Status: ☒ Y ☐ N ☐ U**Seismic Walkdown Checklist (SWC)**

Project: WCNOC SWEL

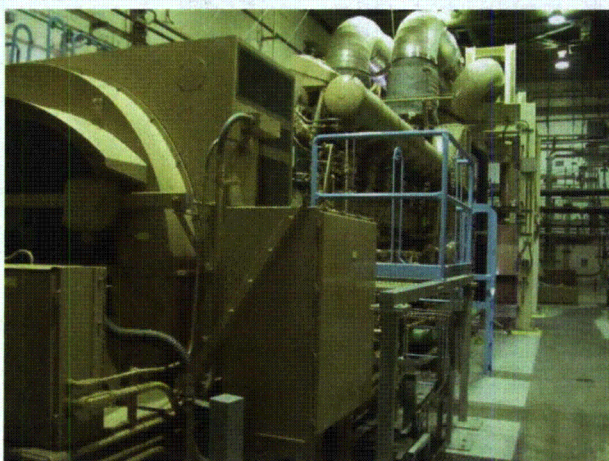
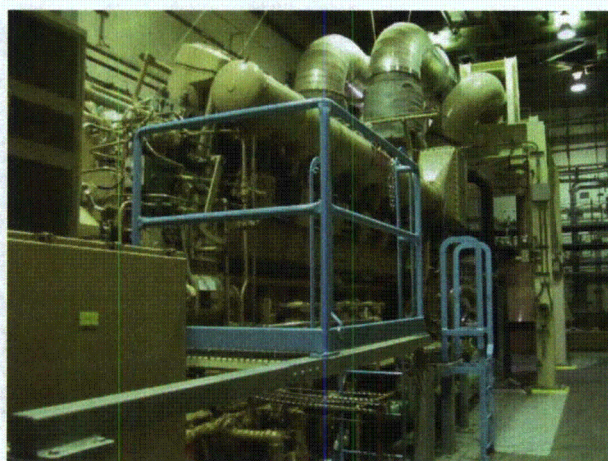
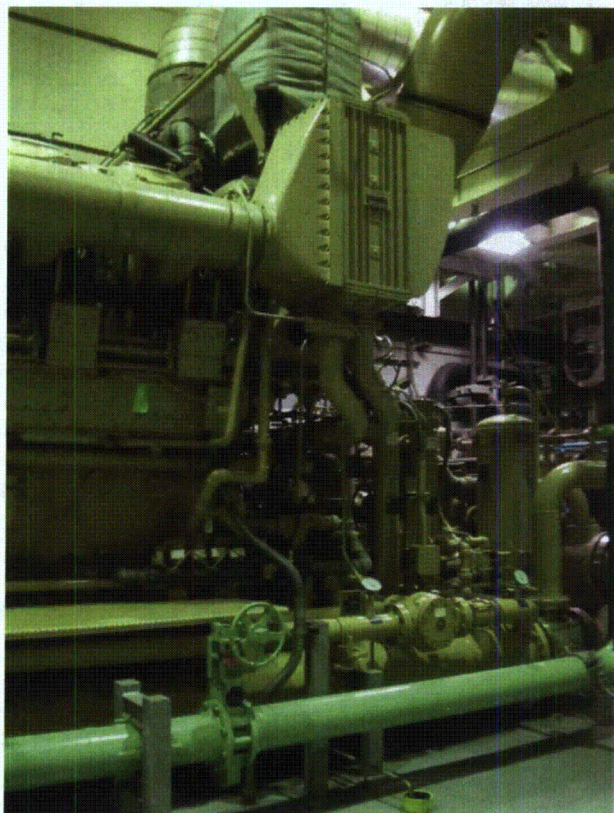
Noted ruggedly-supported crane overhead with hoist chains tied off. Fall protection yo-yos above also well-secured. No hazards.

See Note 7 above. No hazards.

Noted minor surface oxidation on heat exchanger bolts, but no indication of strength loss. Therefore no seismic concern.

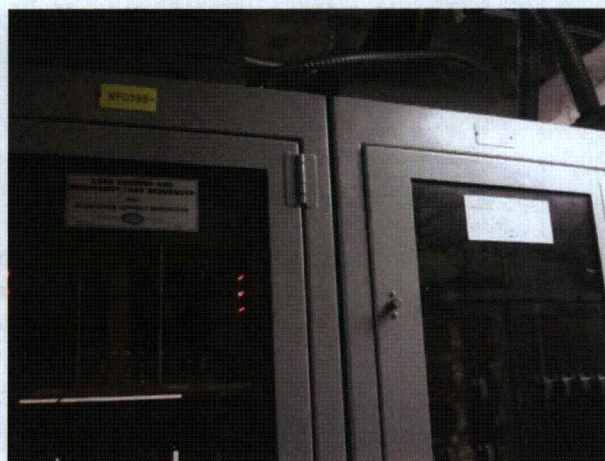
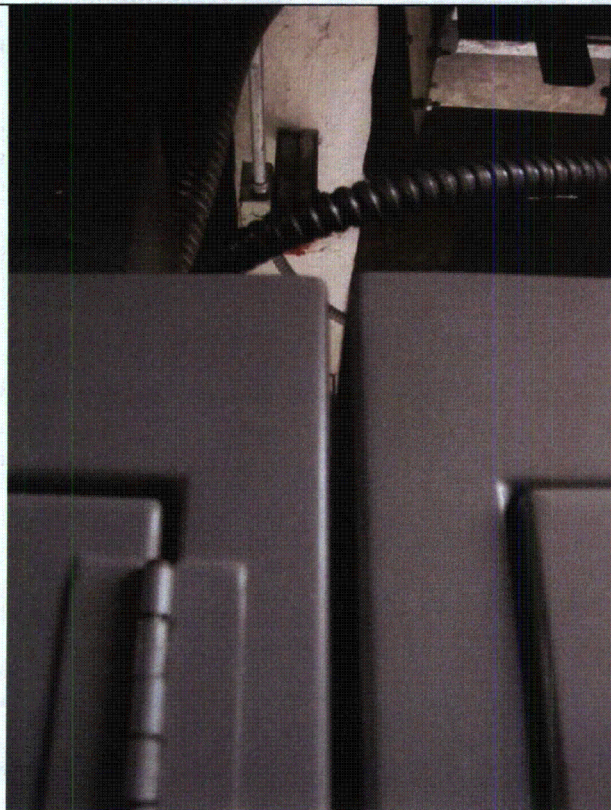
Adjacent cabinets are flush. Concern regarding potential sensitive equipment changing state due to chatter. Check that cabinets are attached.

Licensing Basis Evaluation: SWT review of WCNOG Calculation XX-FH-009-002 confirms that cabinet NF039B and adjacent cabinets NF039A and NF039C have been analyzed for proximity concerns with adjacent cabinets and are therefore acceptable.

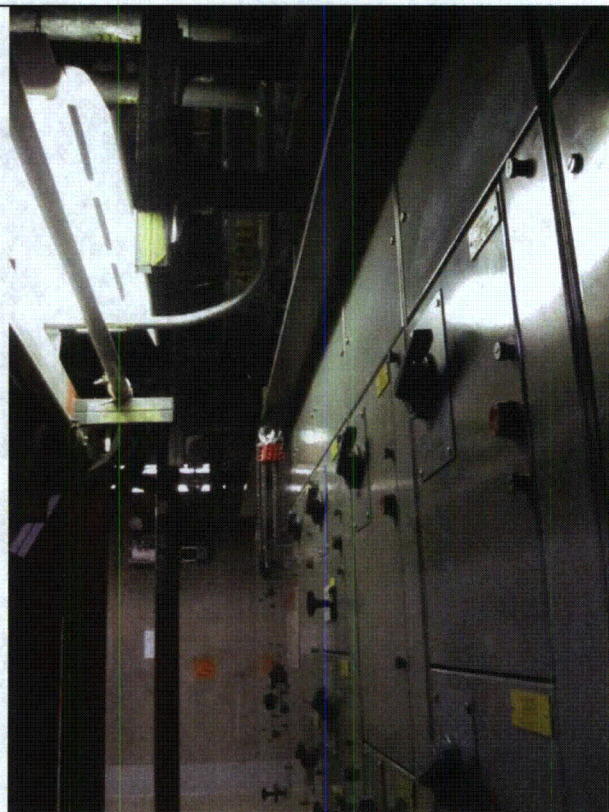
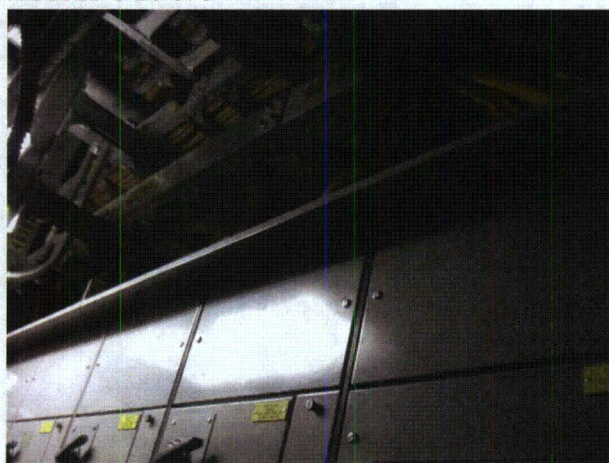
Approximately 3/4" of an inch between top drip shield and P1001 unistrut support on SE corner. From close inspection drip shield edge would pass between P1001 channel flanges, so actual N-S clearance is greater than 2". No spatial interaction concern.

Heavy cable tray observed above but ruggedly supported by P1001 members. No hazard.

Cabinet internals could not be accessed during at-power walkdowns. Internals will be inspected during next bus outage.

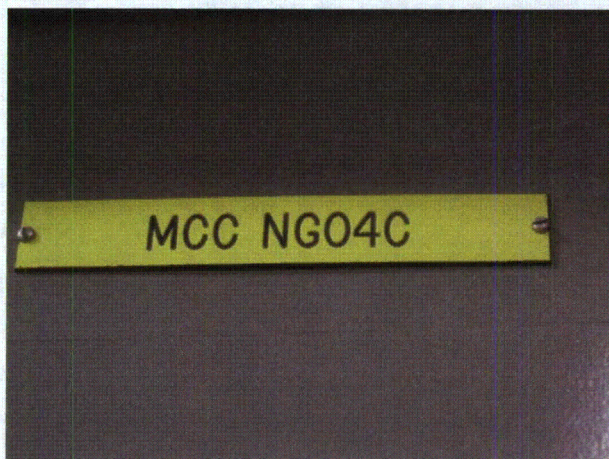
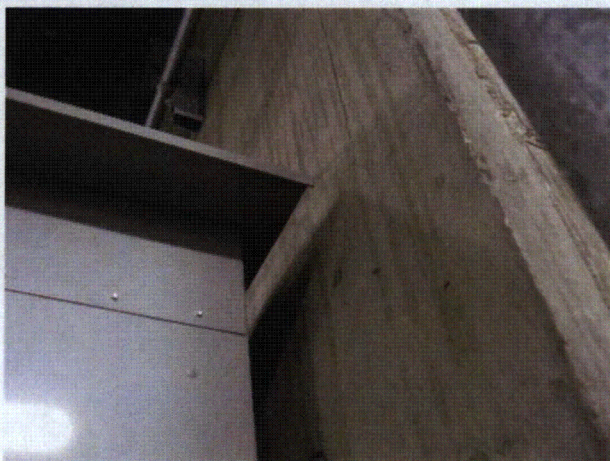
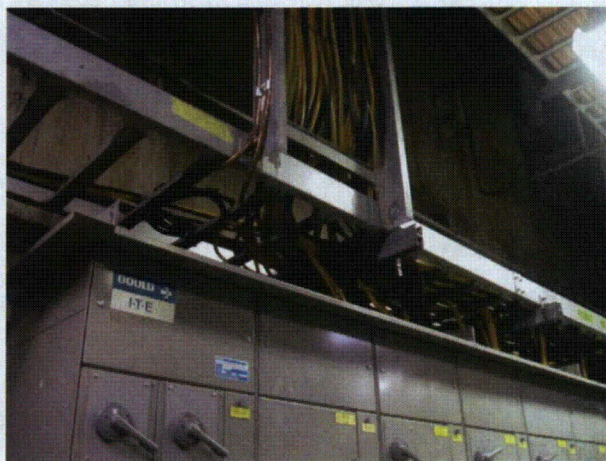
Observed 1-7/8" clearance from back of MCC (drip shield) to concrete wall. There is concern that the MCC could close the gap in SSE event and cause equipment to malfunction. Verification needed to ensure gap is sufficient given MCC flexibility (gap oriented in weak direction) and high elevation of the Aux Building (2047.5').

Cabinet internals could not be accessed during at-power walkdowns. Internals will be inspected during next bus outage.

Licensing Basis Evaluation: Using a conservative lower bound frequency estimate of 5 Hz, a modal shape factor of 1.6 for cantilever action, and taking the peak spectral acceleration of approx. 1g at the 2047.5 ft. elevation for 3% damping (conservative), the upper-bound displacement is 6.3 in ($= 1.6 \cdot 386.4 \text{ in/s}^2 \cdot 1g / (2 \cdot \pi \cdot 5 \text{ Hz})^2$). Therefore, a 1-7/8" gap is acceptable.
